Location of Construction: 20 Island Ave Peaks Island		Owner: W & W Inc. c/o Joseph D Wright	Phone: 766-4400 766-2773	Permit No:
Owner Address: 498 Island Ave, Peaks Island ME 04108	Lessee/Buyer's Name:	Phone:	Business Name: 766 5615	<div style="border: 2px solid black; padding: 5px; text-align: center;"> PERMIT ISSUED Permit Issued: <div style="border: 1px solid black; padding: 5px; margin: 5px 0;"> OCT 16 1998 </div> CITY OF PORTLAND </div>
Contractor Name: SAA	Address:		Phone:	
Past Use: Restaurant	Proposed Use: Same	COST OF WORK: \$ 800.00	PERMIT FEE: \$ 25.00	
Proposed Project Description: Shed roof & wooden walls over existing fire exit from deck and stairs leading to motel rooms & basement		FIRE DEPT. <input type="checkbox"/> Approved <input type="checkbox"/> Denied	INSPECTION: Use Group A-3 Type: 5B BOCA-46 Signature: <i>[Signature]</i>	
Permit Taken By: SP		Date Applied For: October 1, 1998

BUILDING PERMIT REPORT

DATE: 7 OCT, 98 ADDRESS: 20 Island Ave. P.I. CBL Ø84-R-Ø32
REASON FOR PERMIT: Shed roof & wood wall over existing fire exit
BUILDING OWNER: W & W Inc, c/o Joseph D. Wright
CONTRACTOR: SAA
PERMIT APPLICANT: "
USE GROUP A-3 BOCA 1996 CONSTRUCTION TYPE 5B

**Re: Str

Front View of existing building and showing proposed shed roof and walls enclosing existing fire exit ramp and stairs leading to rooms on left side.

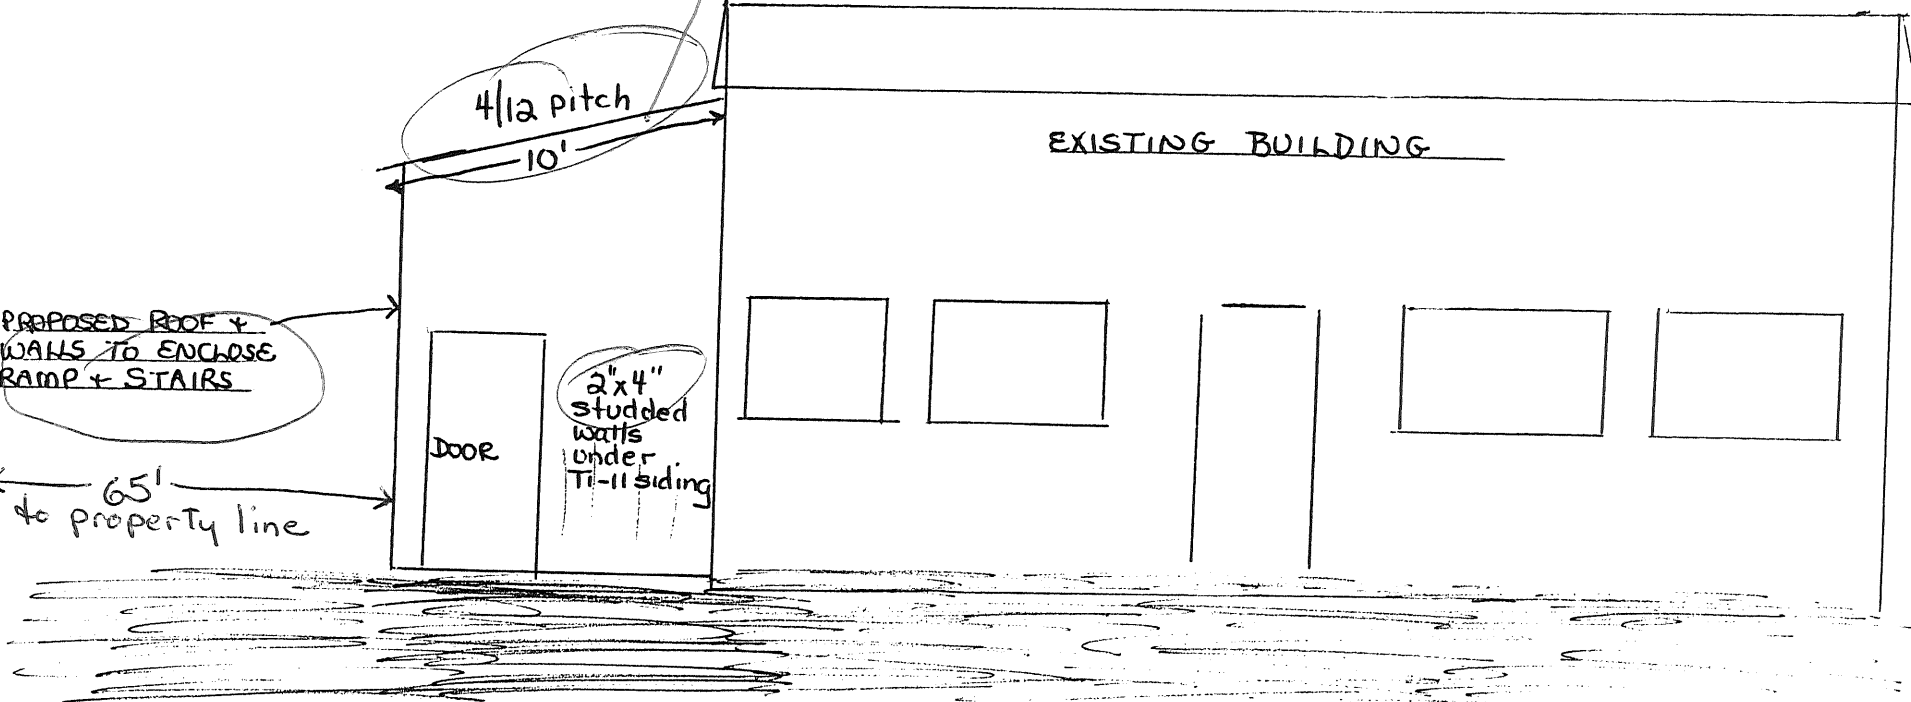
3" x 6" @ 16" o.c.
as per owner
7/OCT

existing ramp + stairs - averaging front setback
→ Along front of

10' req'd on side - 65' shown
10' req'd on rear - 100' shown

FRONT INSIDE VIEW
LOOKING AT RAMP
AND STAIRS

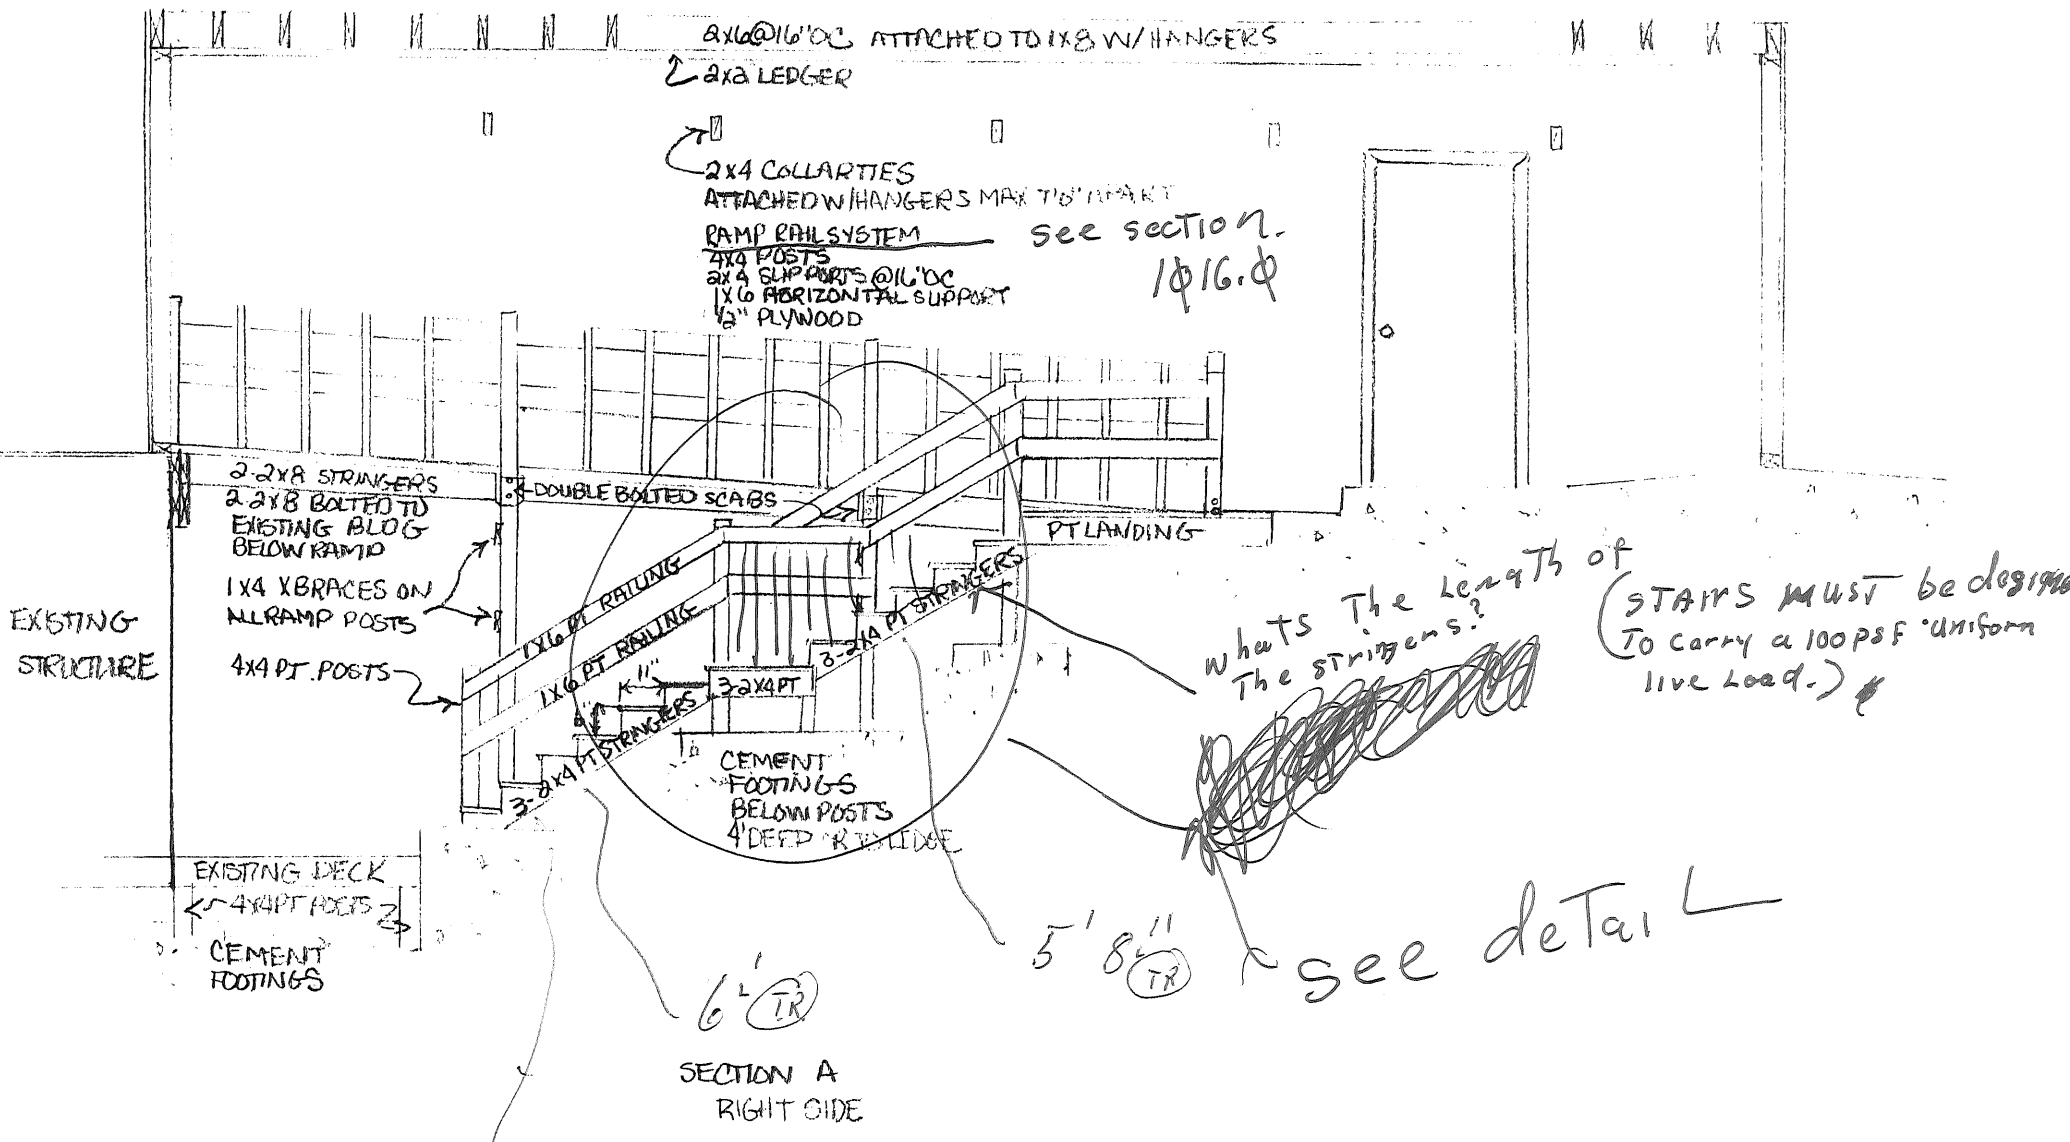
What's the length of the stringers?
 (STAIRS MUST be designed to carry a 100 PSF uniform live load.)

only 2 carriages
 Treads 3 1/4" with 2x12 Treads

5' 8" TR see detail
